HISTORIC AND DESIGN REVIEW COMMISSION

HDRC CASE NO: 2024-120
ADDRESS: 1210 E ELMIRA ST
LEGAL DESCRIPTION: NCB 6796 BLK 8 LOT 1 THRU 3 & S IRR 124.65 OF 4-6 & S IRR 42.09 FT OF 7
ZONING: IDZ, RIO-2
CITY COUNCIL DIST.: 1
APPLICANT: Daniel Elder/OXBOW REAL ESTATE LLC
OWNER: Daniel Elder/OXBOW REAL ESTATE LLC
TYPE OF WORK: Construction of a pedestrian bridge across the San Antonio River
APPLICATION RECEIVED: March 14, 2024
60-DAY REVIEW: May 13, 2024
CASE MANAGER: Edward Hall

The applicant is requesting a Certificate of Appropriateness for approval to construct a pedestrian bridge across the San Antonio River from Brewmeister's Alley at Pearl to the existing Elmira Street parking lot, the future site of development on the west side of the river. The proposed bridge will feature a span of approximately 105 feet, and feature a painted, steel box truss design with western red cedar decking.

Site Plan

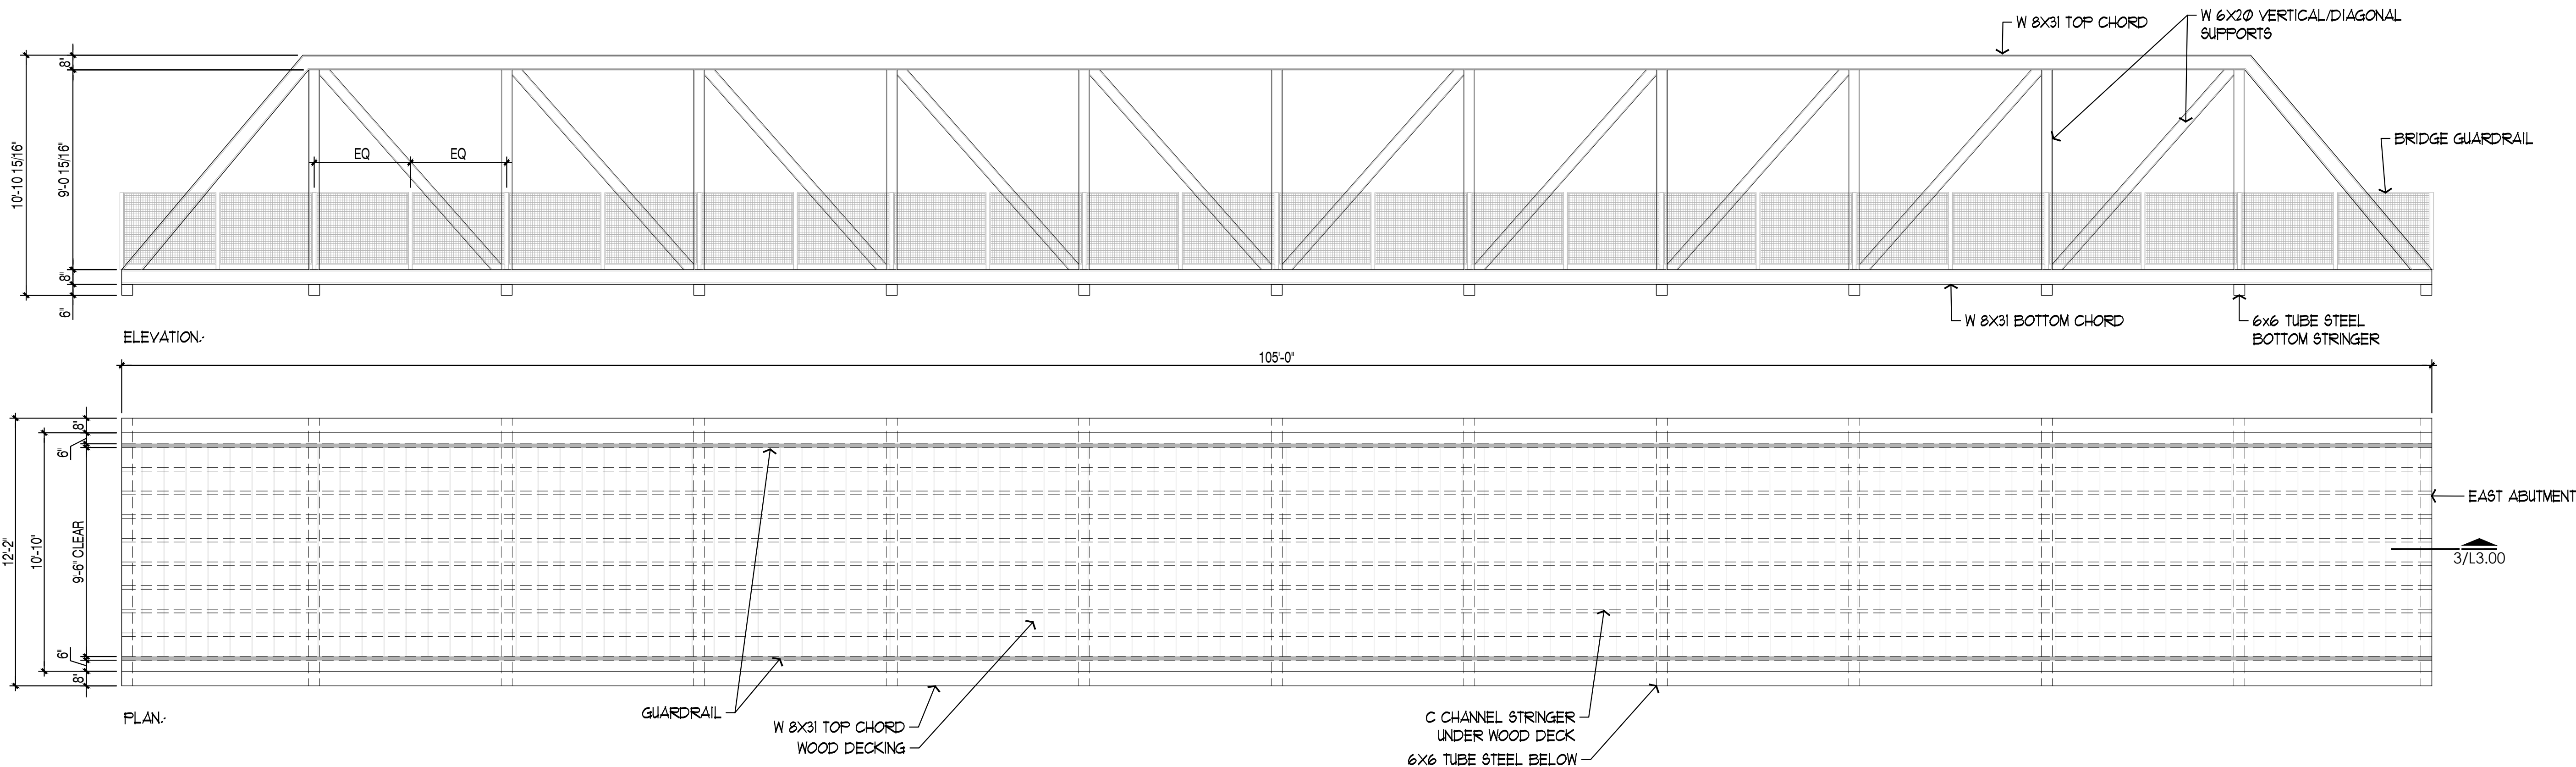
- f. LANDSCAPING/HARDSCAPING – The applicant has noted the installation of both hardscaping and landscaping items to facilitate pedestrian access to and from the proposed pedestrian bridge. At the bridge landing on the west bank, the applicant has proposed native hardwood mulch, has proposed to preserve existing trees, and has proposed to plant shrubs and ground cover on the east bank. Staff finds the proposed landscaping to be appropriate and consistent with the UDC.

1 DETAIL: PEDESTRIAN BRIDGE

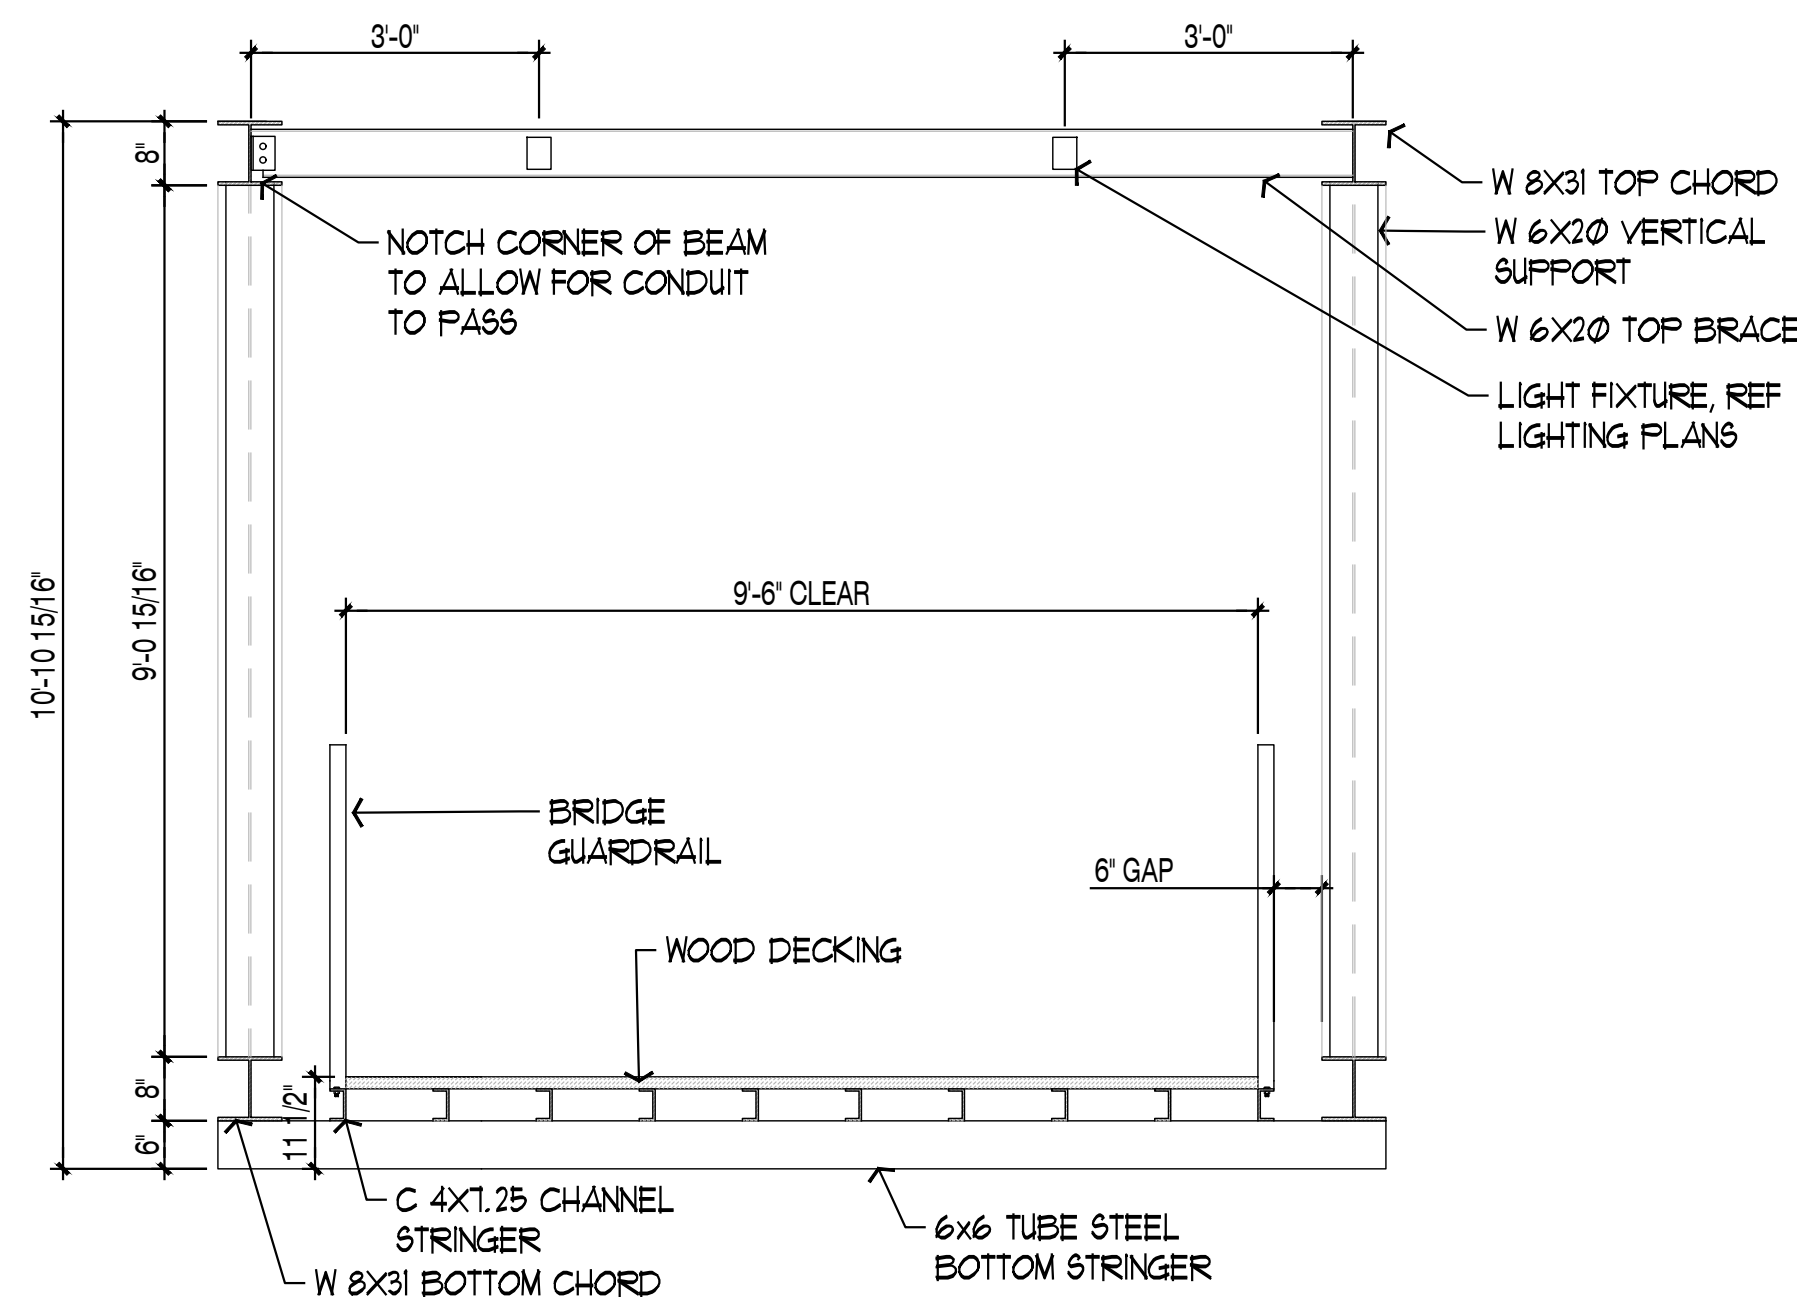
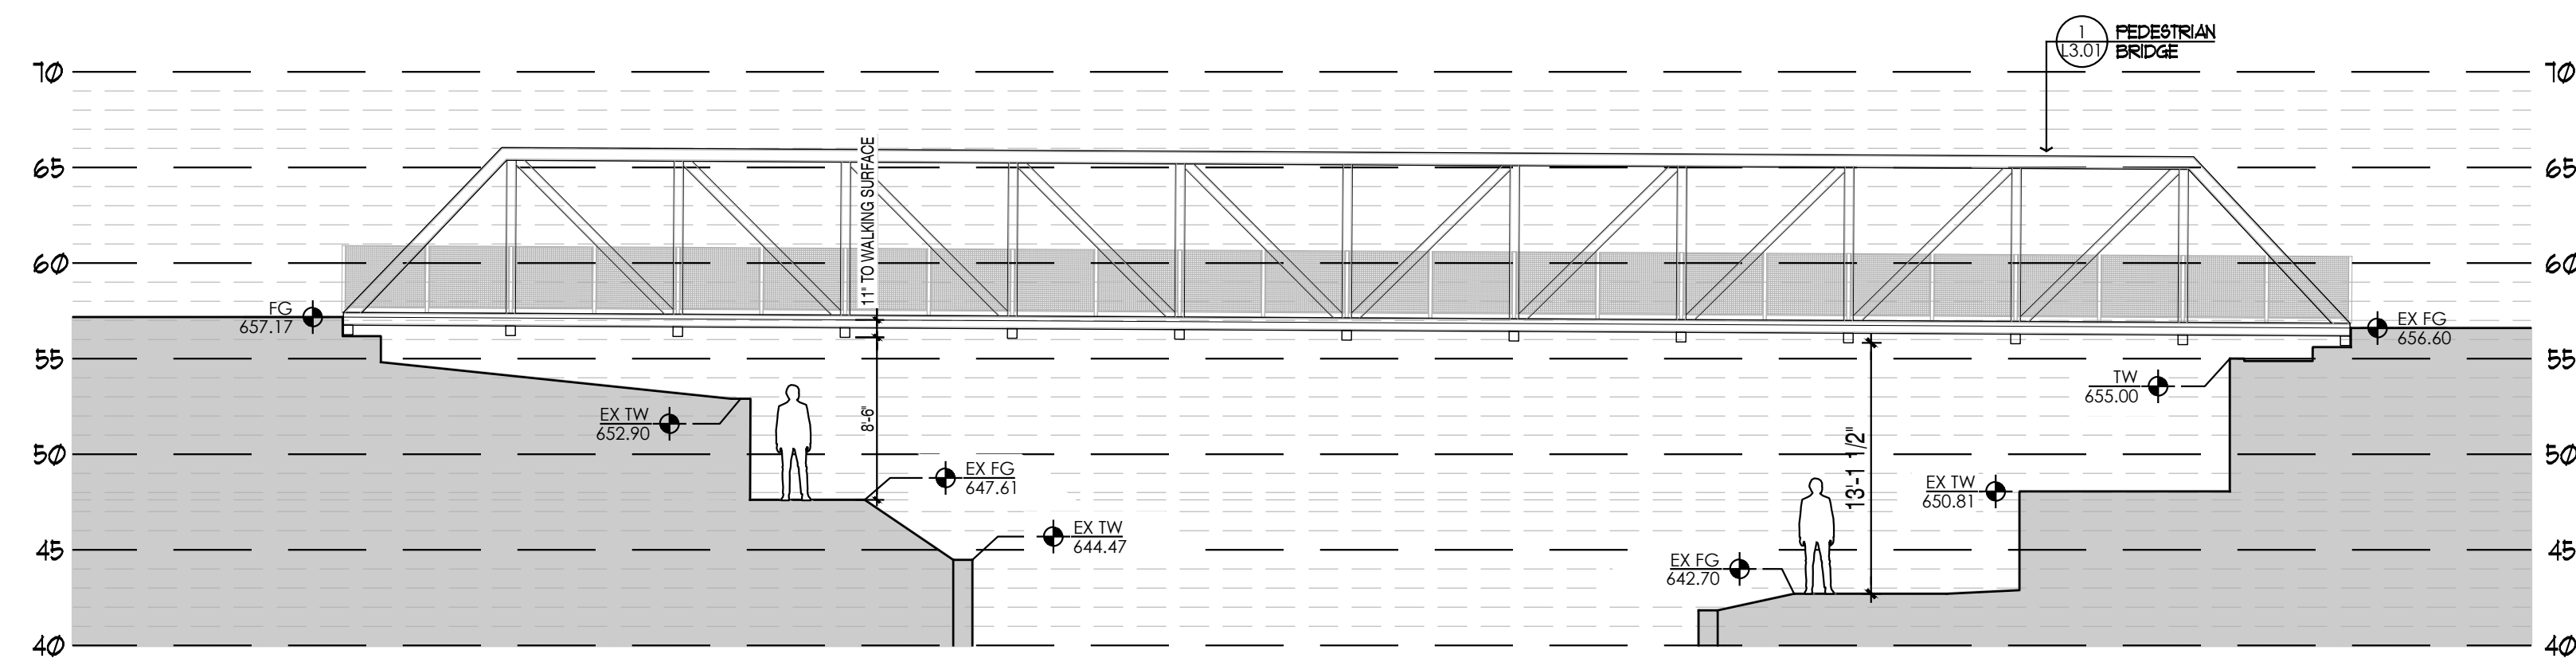
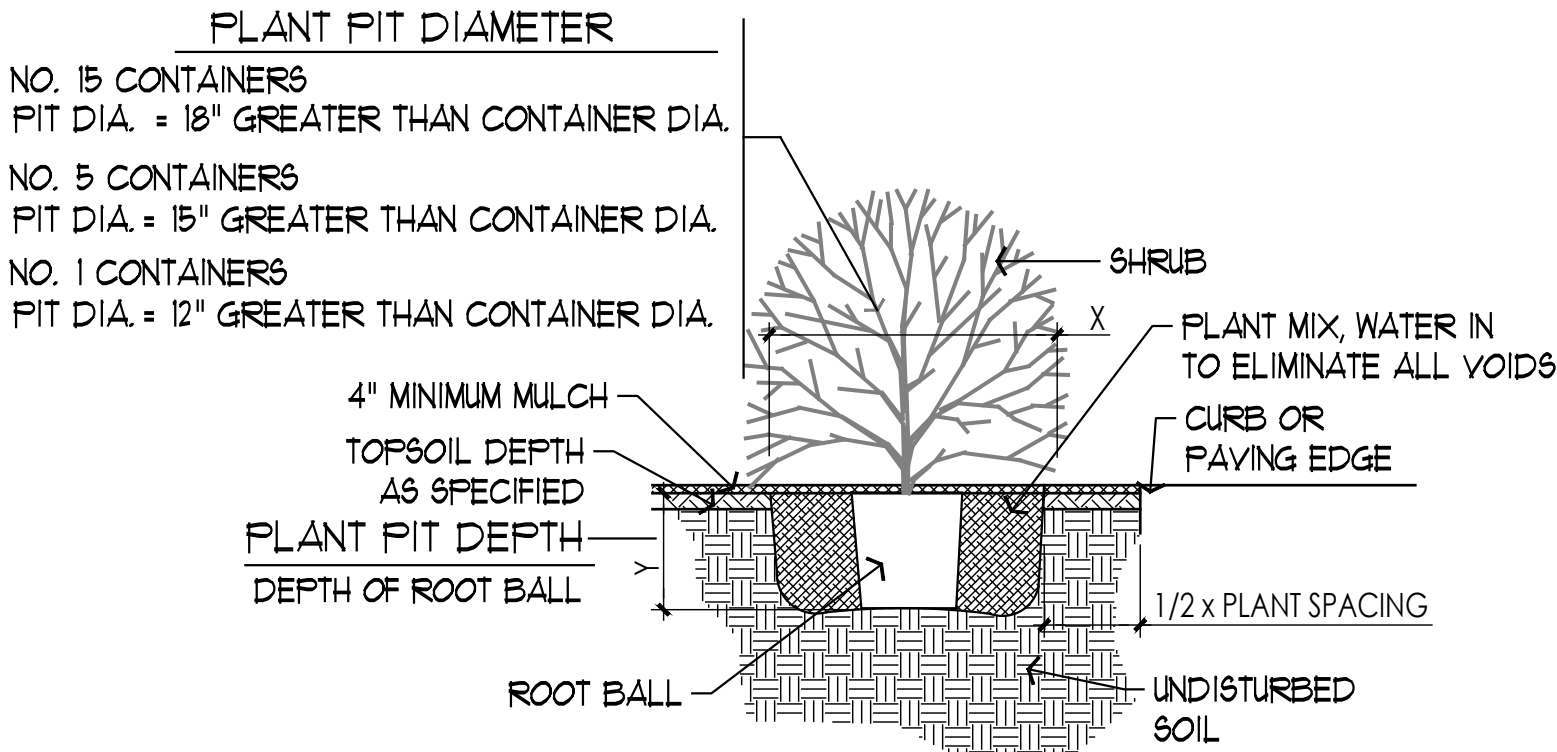
- d. PEDESTRIAN BRIDGE – The applicant has proposed for the bridge to feature an overall span of approximately 105 feet, with clearances above the pedestrian path at the Riverwalk of 8' – 6" on the west side and 13' – 2" on the east side. Staff finds this to be appropriate.

- e. PEDESTRIAN BRIDGE (Materials) – The applicant has proposed for the bridge to feature materials that include a painted, steel box truss design and western red cedar decking. The applicant has submitted construction documents noting the profile and detailing of each. Staff finds the proposed materials to be appropriate.
